Decision Report

Application for Works Approval

Works Approval Number W6824/2023/1

Lot 1801 Banksia Road, Hithergreen, WA 6280

Figure 2: Noise levels assuming no noise mitigation

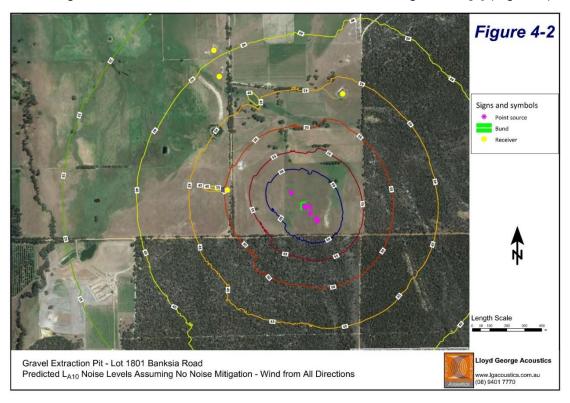
The noise report results indicate: "noise levels resulting from the extraction and crushing works, during the hours 7.00 a.m. to 7.00 p.m. Monday to Saturday, are predicted to exceed the assigned level of 45 dB LA10 at two locations, being Lot 94/201 Williamson Road and Lot 93/59 Banksia Road. The noise to all other noise sensitive premises is predicted to comply"[6](Figure 2). "To address the noise, it is recommended to construct a series of earth bunds and restrict the area in which the dozer can operate. The location and height of the bunds, together with the dozer restriction zone is detailed in Figure 5-1"[6] (Figure 3).

However during construction of the proposed bunding, the noise level is predicted to be as high as 57dB at the closest receptor and to have a high impact on the amenity of the nearby receptors. DWER requested the applicant develop a bunding construction noise management plan, detailing the expected timeframe of construction and noise mitigation methods. The applicant advised the proposed controls listed in Table 1. The applicant should clearly indicate that during bund construction, it is a construction site and the work is construction work, as specified under Regulation 13 of the noise regulations.

Technical advice also indicated that the overall background noise level for the day period is very low (27dB) and the proposed operation will significantly increase the ambient noise levels in the nearby area. Such impact may attract noise complaints from the closest receptors and should be prepared to take actions to address it if it occurs.

Figure 4: Scenario 4 with noise mitigation - wind from all directions

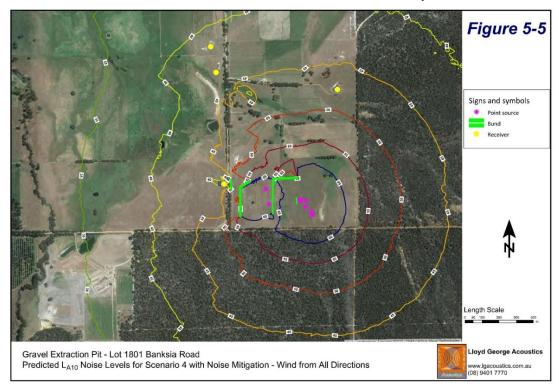
The noise report contains 6 scenarios of predictive modelling with noise bunding. Figure 4 illustrates the worst-case scenario with noise bunding which demonstrates compliance of noise with the assigned noise level. The noise report concluded "that compliance with the applicable assigned noise level can be achieved at all noise sensitive receivers between 7.00 a.m. and 7.00 p.m. Monday to Saturday, providing the dozer is restricted to certain areas and a series of earth bunds are constructed on the western boundary of the extraction area" [6].

DWER's internal technical advice concluded the noise levels in the report are likely to be representative and acceptable, and the proposed controls are effective and appropriate. They concluded that noise from the gravel extractive operation can be managed to comply with the daytime assigned noise levels at all neighboring noise sensitive premises.
